**Addendum No. 3**  
Page 1 of 23

**TO:** Prospective Respondents  
**SUBJECT:** Addendum No. 3  
**PROJECT NAME:** Romeoville Campus Expansion Bid Release 2  
**JJC PROJECT NO.:** B15028

This Addendum forms a part of the Bidding and Contract Documents and modifies the original bidding document as posted on the JJC website. Acknowledge receipt of this addendum in the space provided on the Bid Form. FAILURE TO DO SO MAY SUBJECT BIDDER TO DISQUALIFICATION.

P112.02

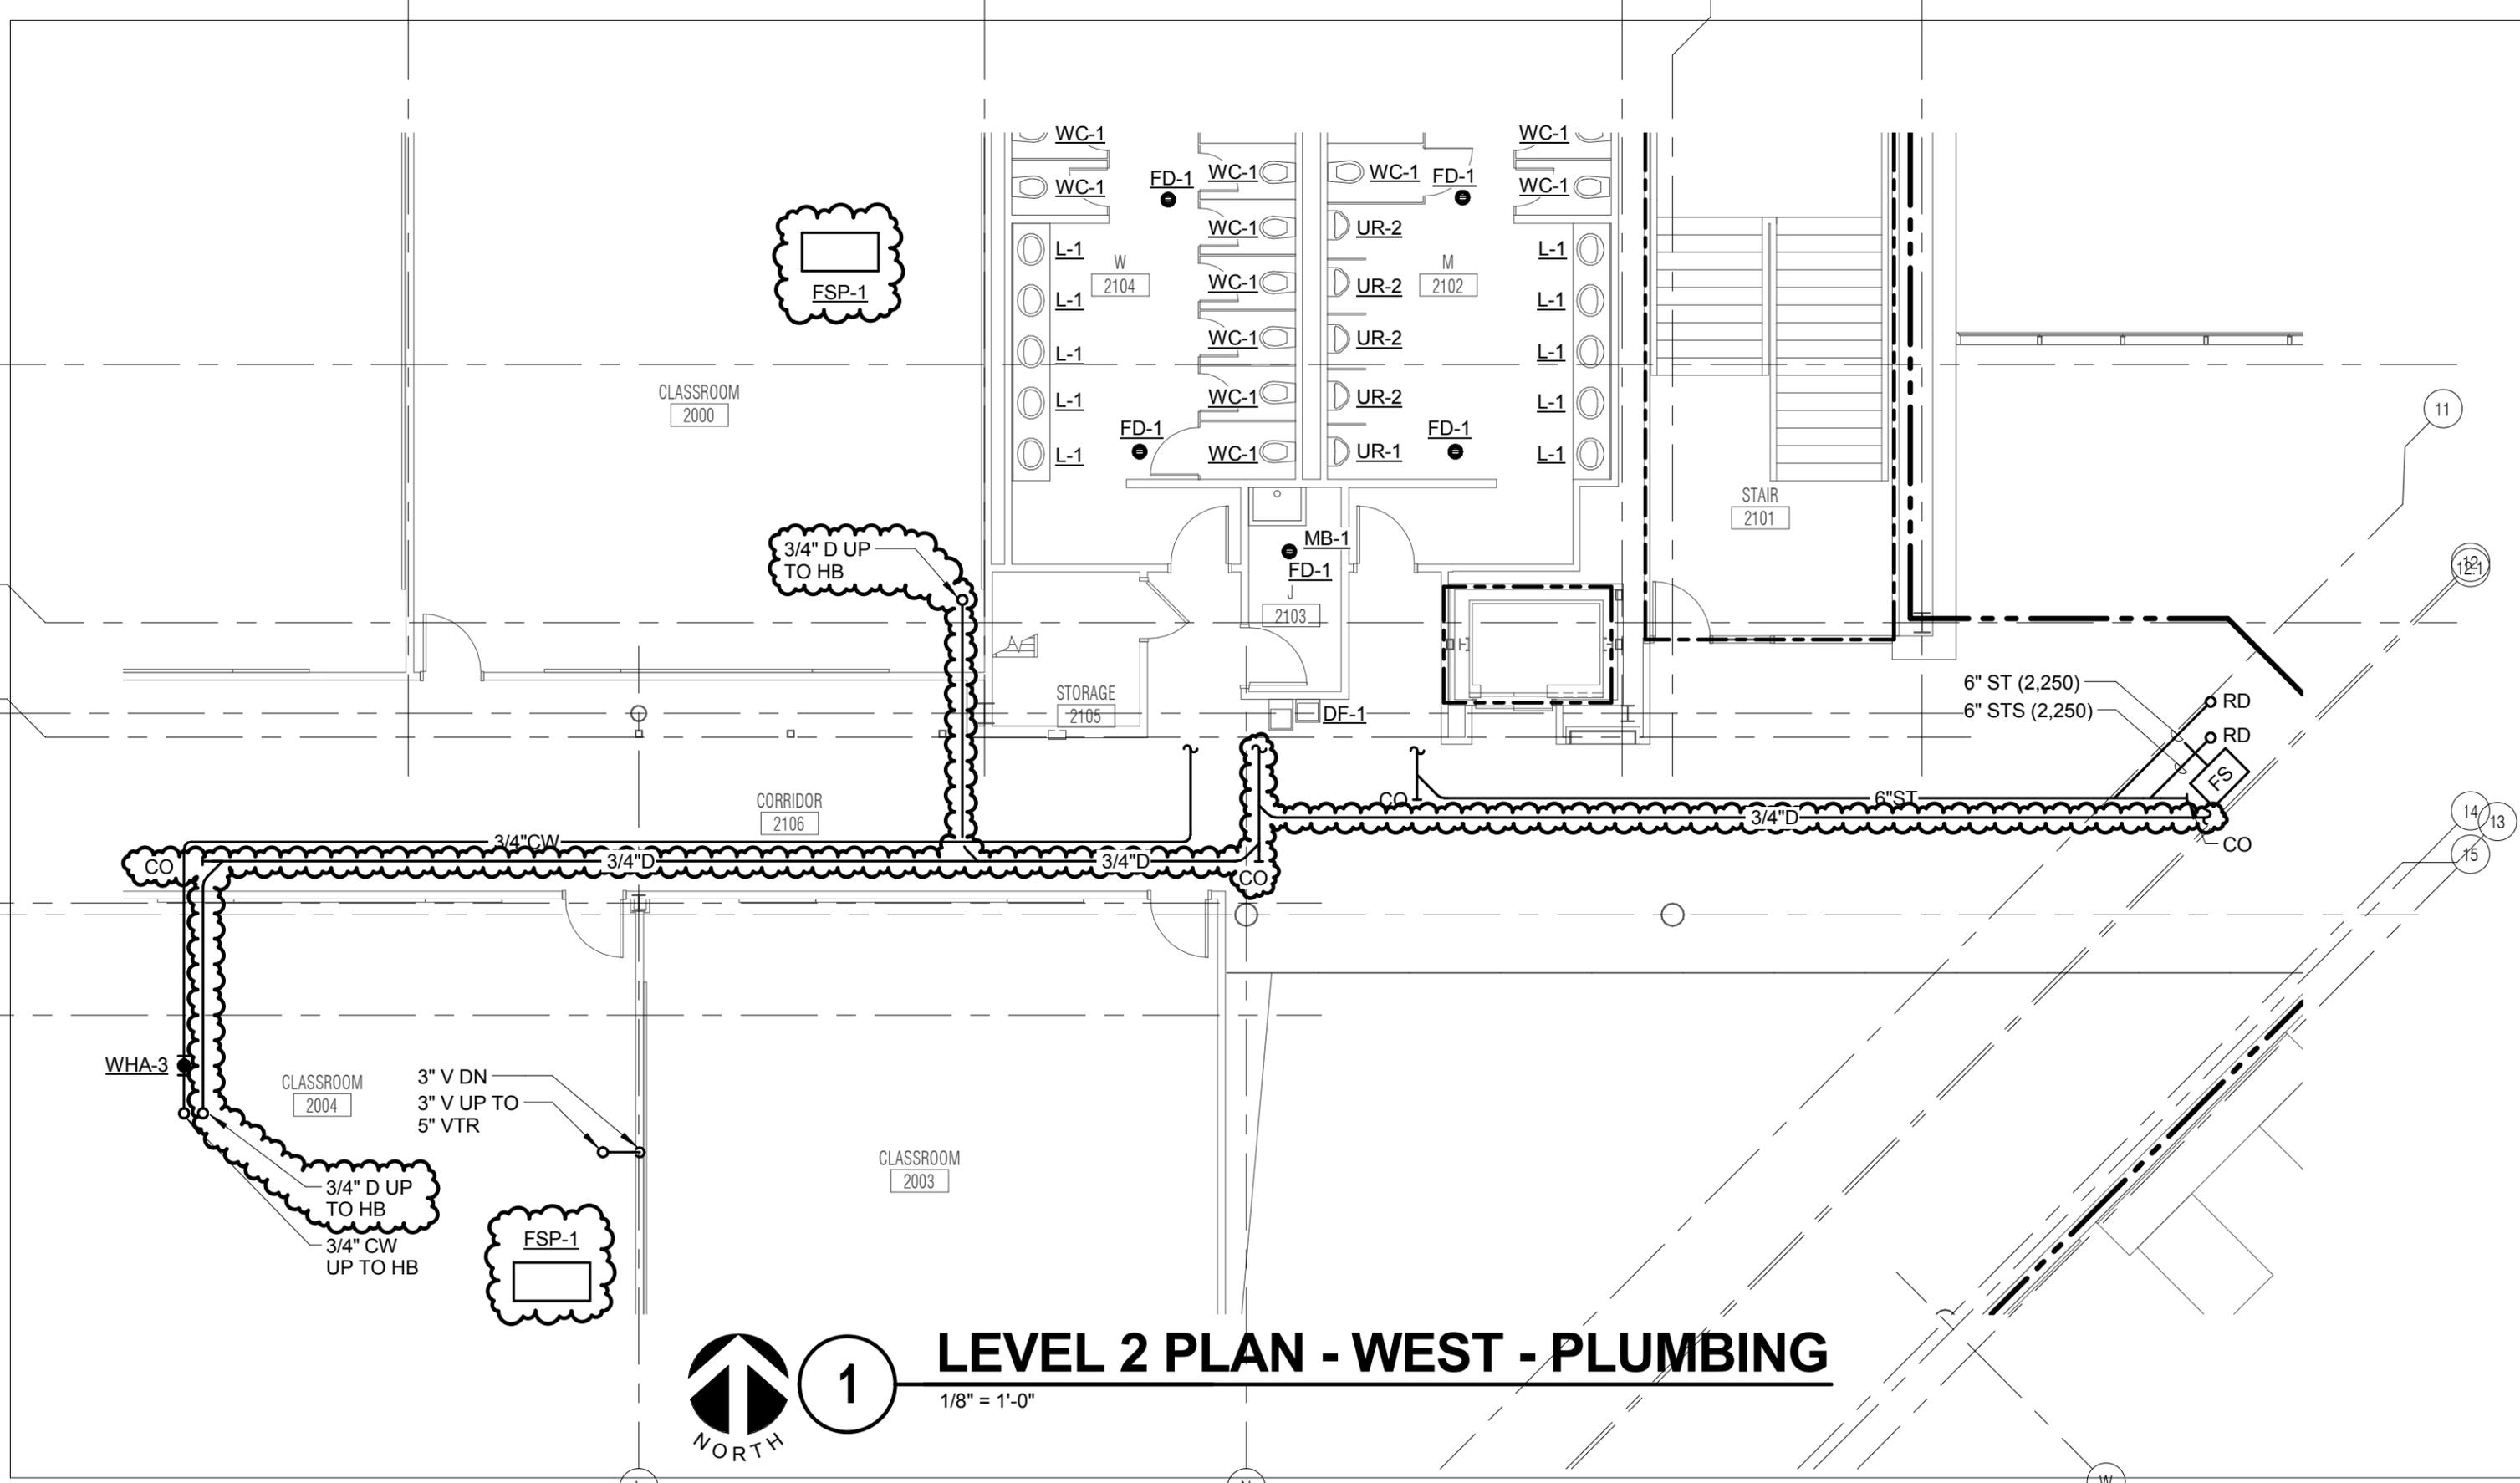
2. **ADD** new hose bib and associated piping at the exterior wall of Financial Aid 1026. **REVISE** location of hose bib and associated piping at the exterior wall of Small Testing Room 1040. Refer to P112.02 for more information.

ADDENDUM 3  
**P121.01**

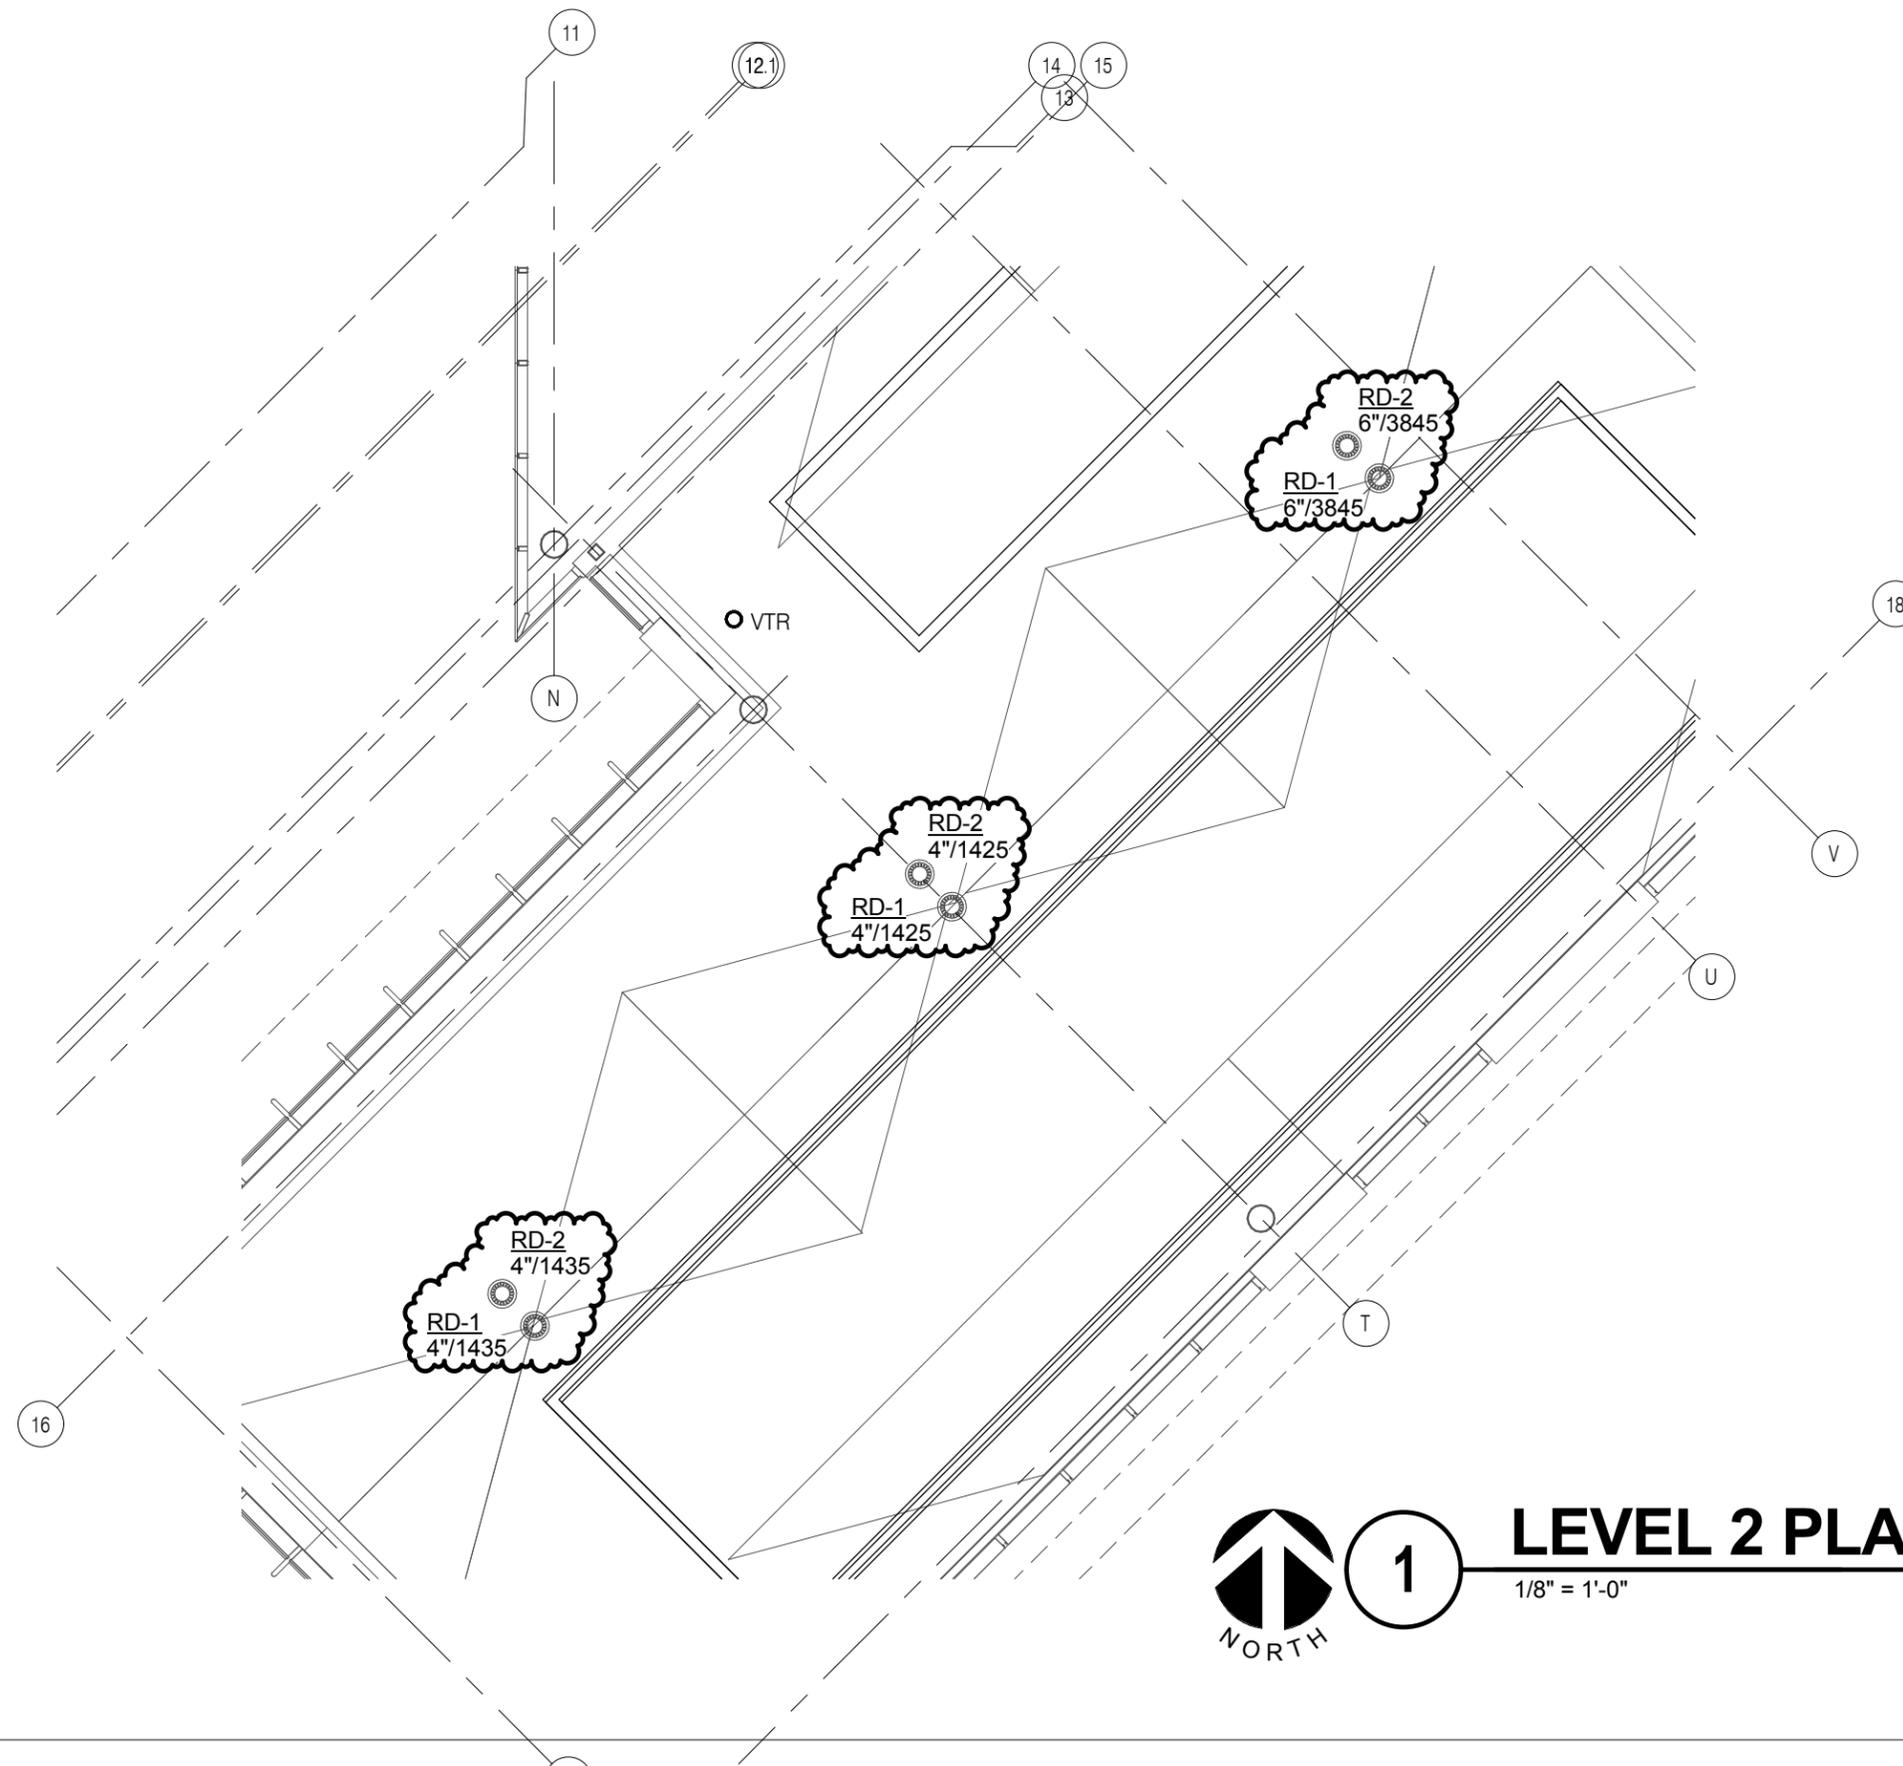
3. **ADD** new ¾" drain piping for hose bibb which terminates to the mop basin in J 2105. Refer to P301.01 for more information.
- F. Drawing P1.21
1. **ADD** drain for hose bibb located on the roof of Classroom 2004 & Classroom 2000. **ADD** flow sensor panels (FSP-1) for secondary roof drain sensor. Refer to P121.01 for more information.

ADDENDUM 3  
**P121.02**

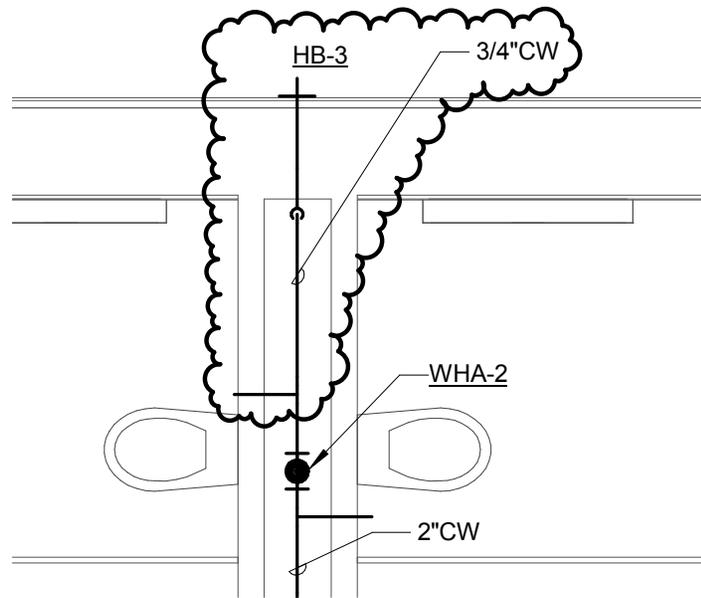
2. **MODIFY/SWITCH** primary and secondary roof drain locations for Dining and Multipurpose roof. Refer to P121.02 for more information.
- G. Drawing P1.22

ADDENDUM 3  
**P303.01**

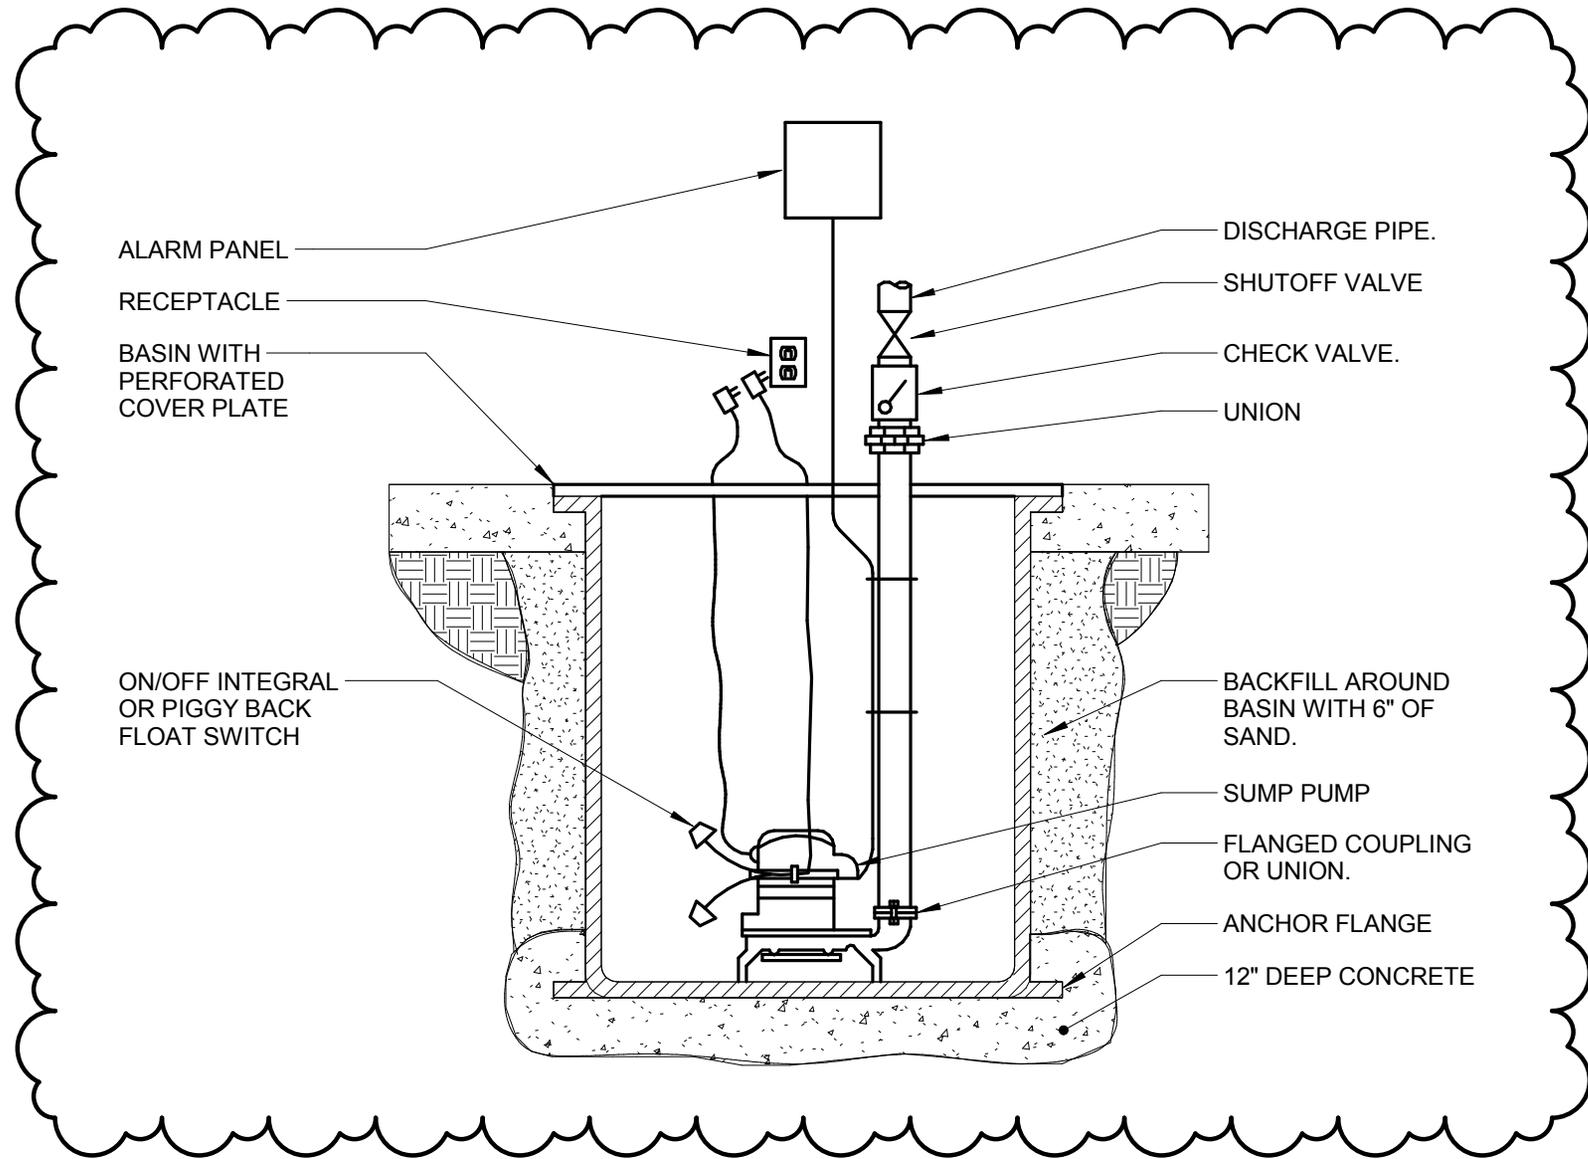
- b. **RELOCATE** 2/P1.32 ROOF PLAN-EAST-PLUMBING-ALT BID1 FROM P1.32 TO P1.22.
- J. Drawing P3.03
  - a. **ADD** shut off valves to the CW piping serving the water heaters, water softeners, hose bibb and back flow preventer in Mechanical 1111. **ADD** shut off valves to HW, HWC & HWC140 pipes serving the water heaters. **REVISE** locations of Mixing valve detail reference note & Water Heater detail reference note. Refer to P303.01 for more information.
